## WYOMING STATE PENITENTIARY Independent Peer Review Study

### **Final Report**

WJE No. 2017.3123

### **Members, Joint Appropriations Committee**

*Figure 1. Building identification, with Areas in the South Facility Housing Unit*

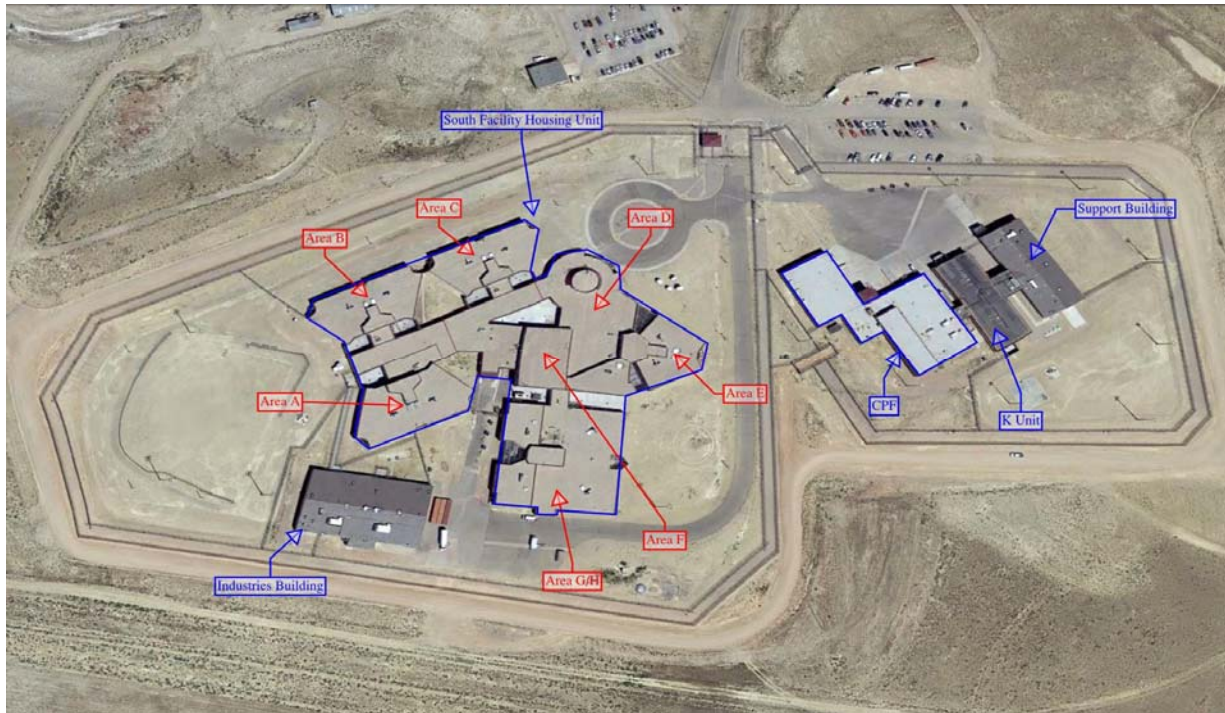
The Wyoming State Penitentiary property, located in Rawlins, Wyoming, includes a North Facility and a South Facility. The North Facility opened in about 1980; however, due to safety concerns, the North Facility was abandoned following construction of the South Facility Housing Unit in 2001. The penitentiary buildings currently in use are identified in Figure 1 and now include the following:

PARTIAL  
SHEET 57

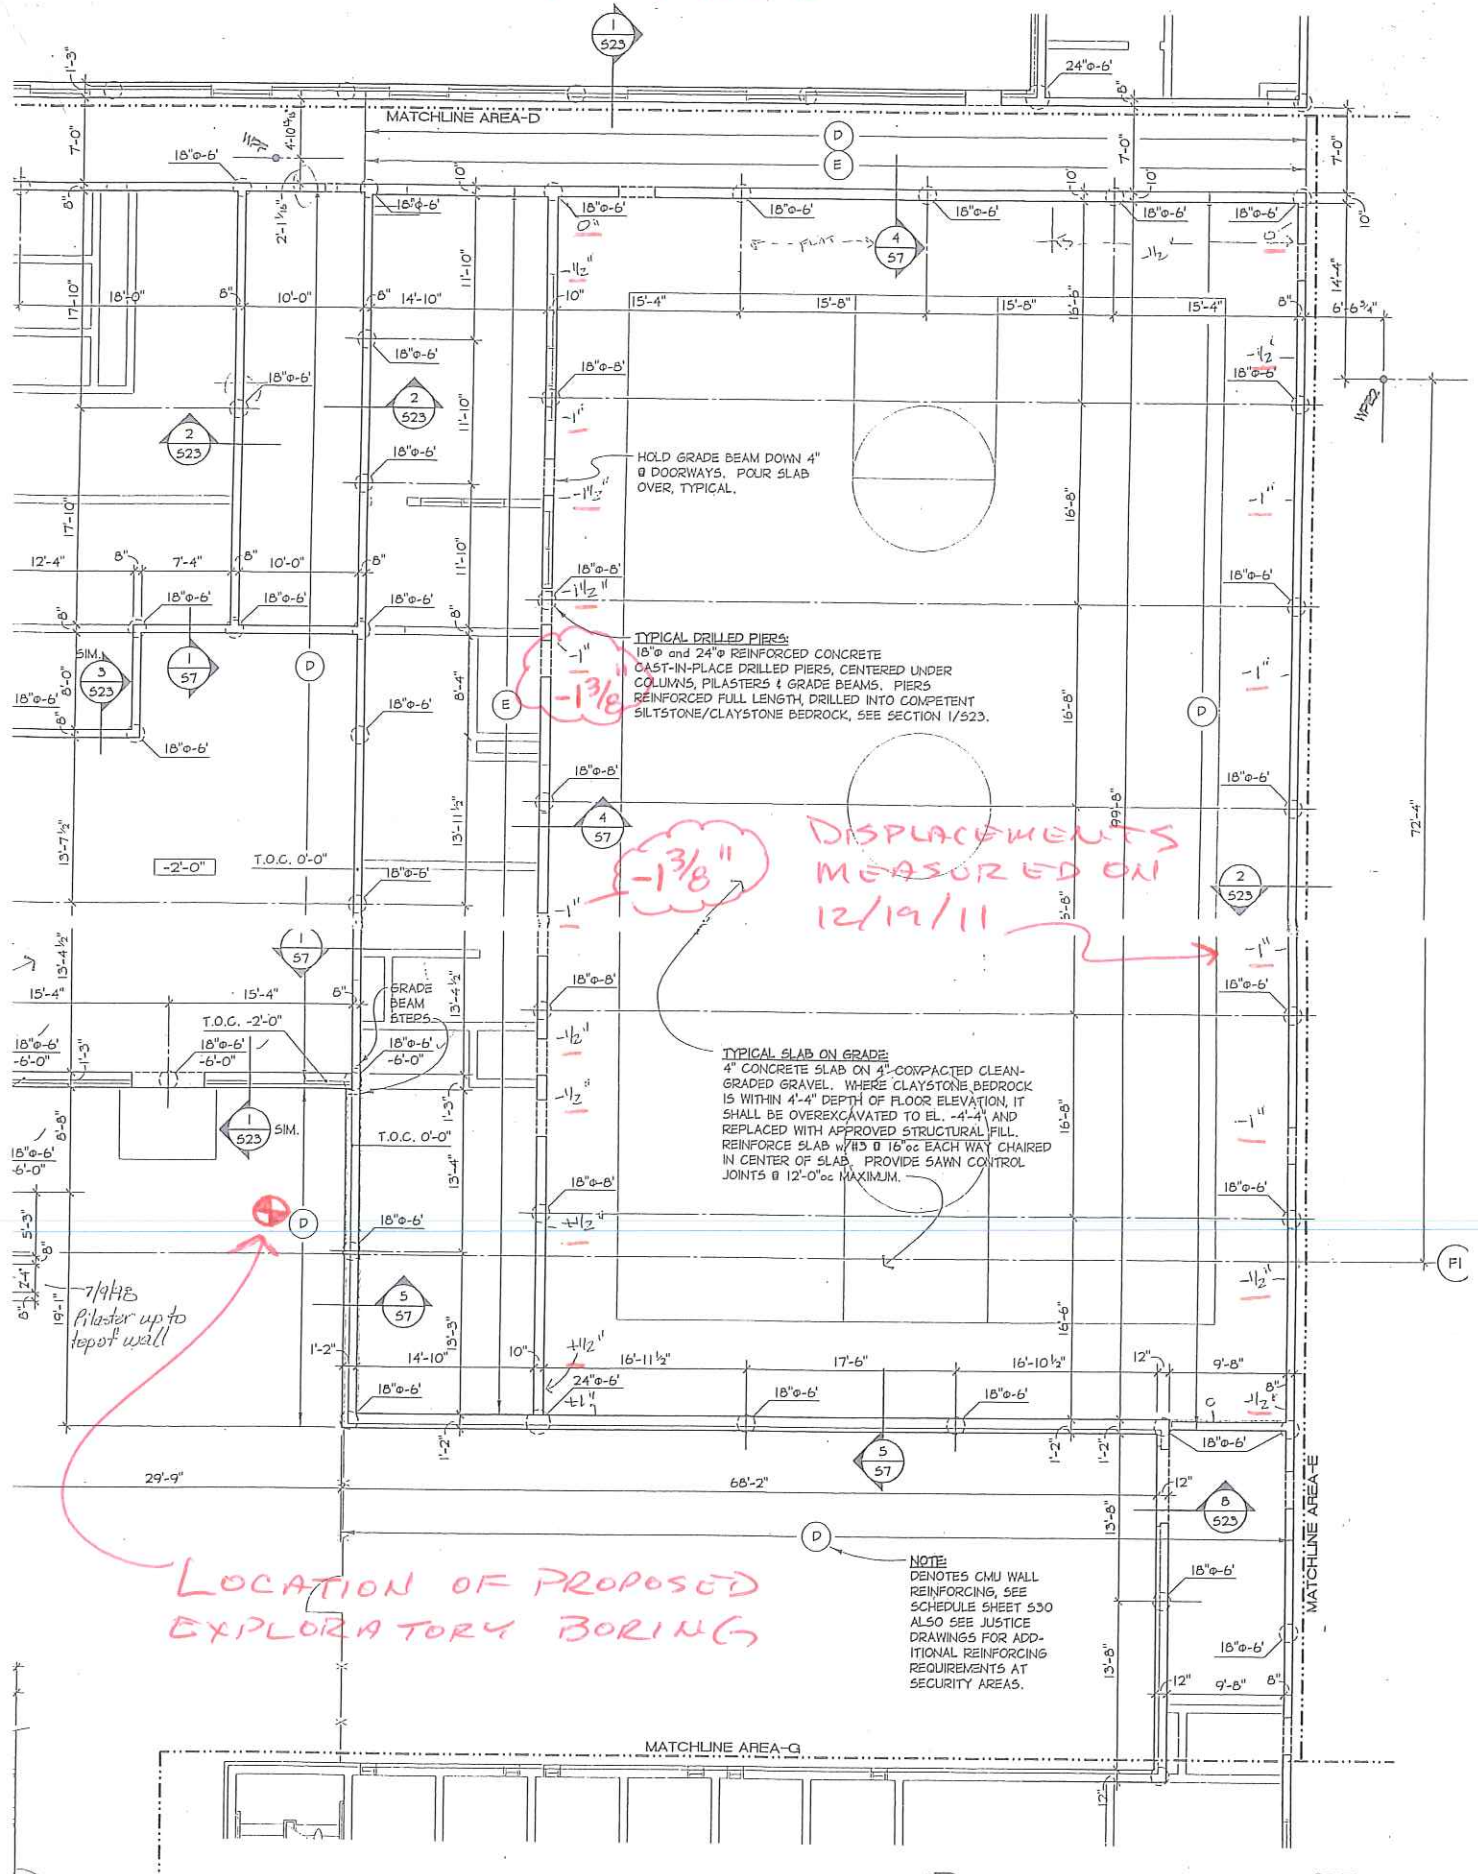
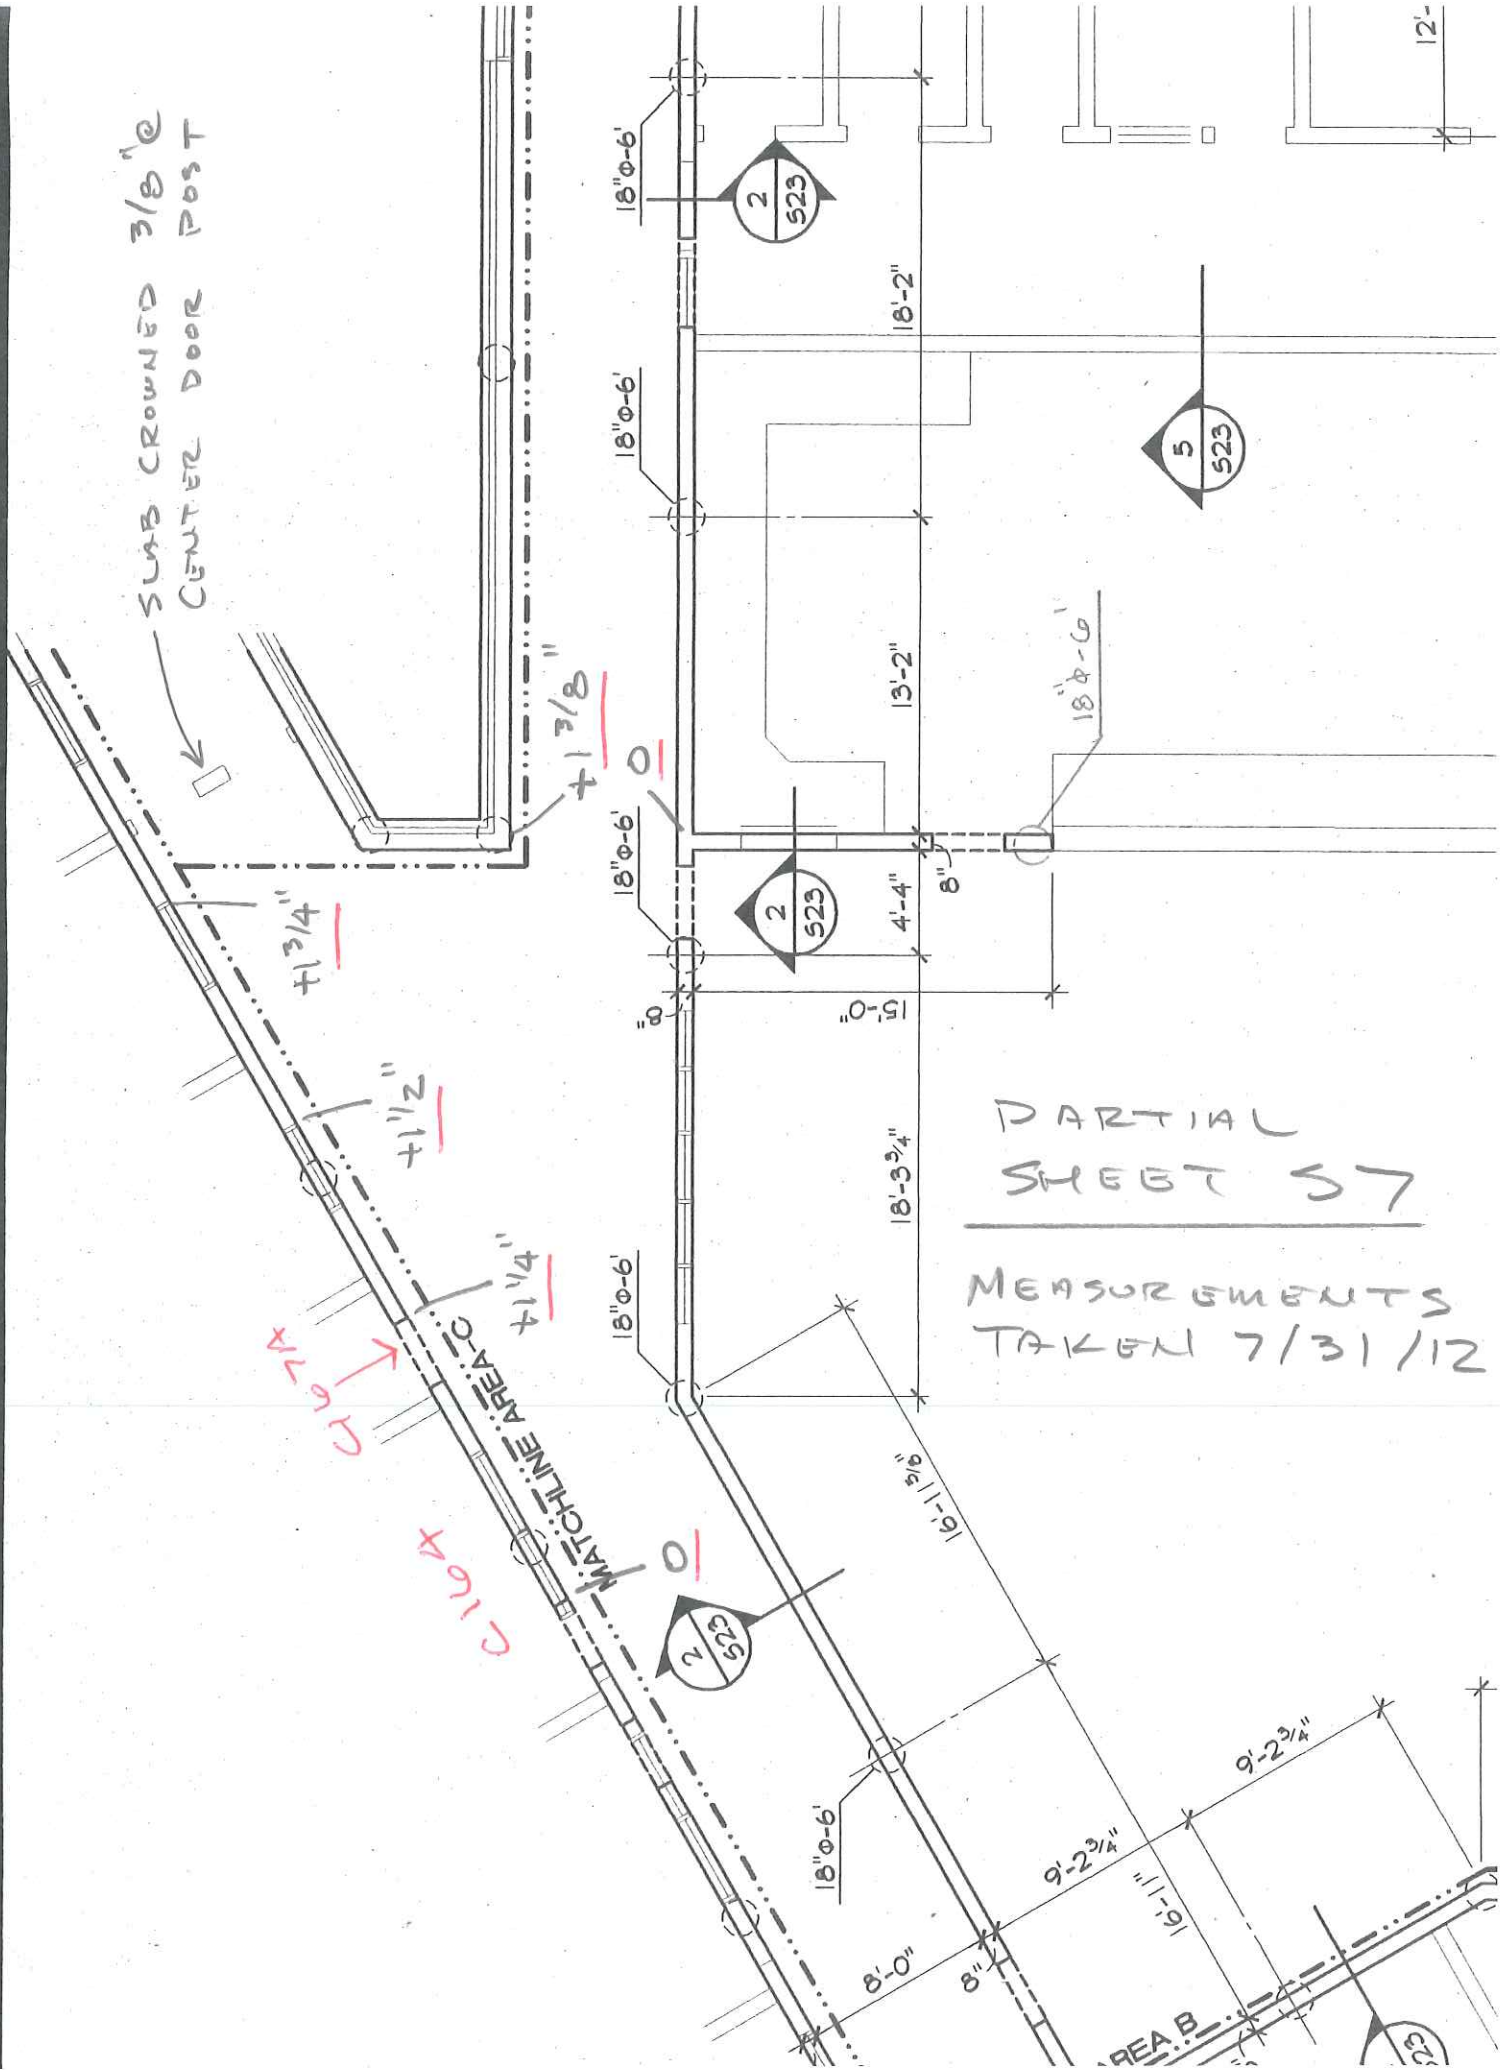
**Gymnasium:** See attached partial sheet S7. It is apparent that the grade beams supporting the east and west Gym walls have settled. Diagonal cracking and door/window frame distortion indicates that the walls have displaced downward toward the center of the Gym wall relative to the north and south ends of the Gym. I measured vertical displacements of the walls and floor slabs of a maximum of 1 1/2" at the west wall and 1" at the east wall. Staff members that have been at the facility since it's construction stated that this movement has been slowly progressing since the building was completed.

**Gymnasium:** See attached partial sheet S7. It is apparent that a central portion of the grade beams supporting the west Gym wall has settled further since December 2011. The magnitude of the additional displacement is approximately 3/8" downward. Measurements of the east, north and south walls of the Gym indicate that they have not displaced since December 2011. There is still no need to discontinue use of the Gym, the building is safe to occupy and use. The amount of movement is not enough to cause any instability of the structural walls or roofs.

CLOUDED AREAS SHOW FURTHER MOVEMENT  
 MEASURED 7/31/12 (NOTED MOVEMENT  
 MEASURED 12/19/11.)

SLAB CROWNED 3/8"  
CENTER DOOR POST

**Recommendations:**

SECTION - B  
3/4" = 1'-0"

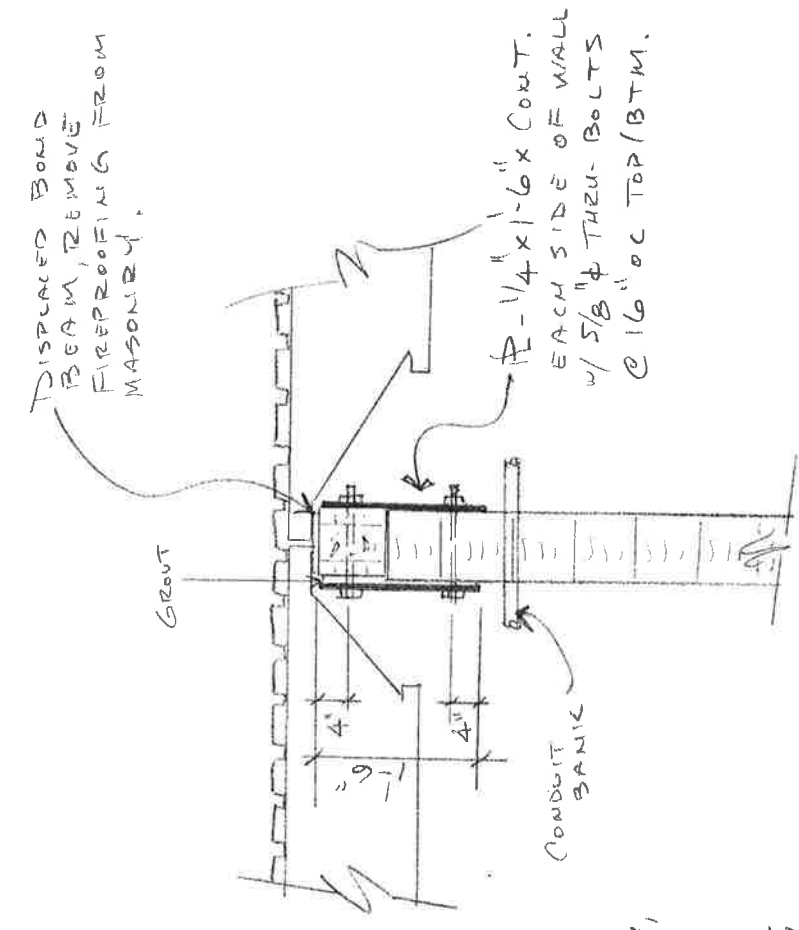
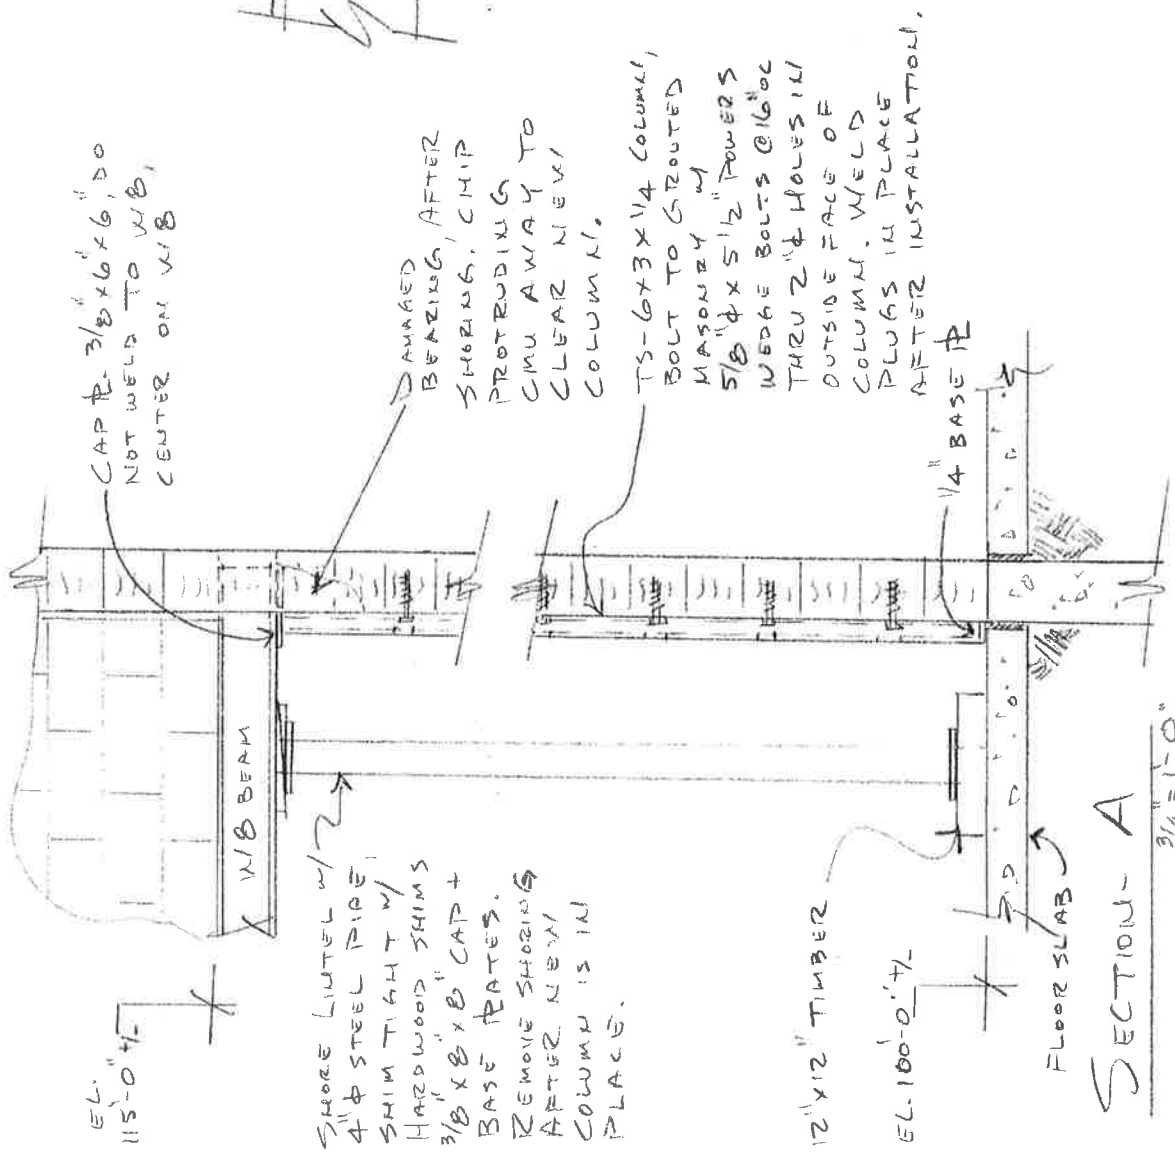
We observed an area of concern in the CPF at the Mechanical Room. The masonry column surround that covers a steel column in the wall has separated from the wall masonry. This surround should have been provided with a caulked control joint where it meets the wall, but the joint was mortared instead. The CMU soaps that extend above the top of the column into the web of the W24 steel beam that is supported by the column are loose and should be removed. It is not necessary to replace these CMU soaps. The mortar that is damaged and cracked at the surround / wall joint should be removed and replaced with backer rod and paintable caulking.

DISPLACED BOND BEAM, REMOVE FIREPROOFING FROM MASONRY.

$\phi - 1/4" \times 16" \text{ CONT.}$   
EACH SIDE OF WALL  
w/  $5/8" \phi$  THRU-BOLTS  
@ 16" OC TOP/BTM.

CAP  $\phi - 3/8" \times 6" \times 6"$ , DO NOT WELD TO W8, CENTER ON W8.
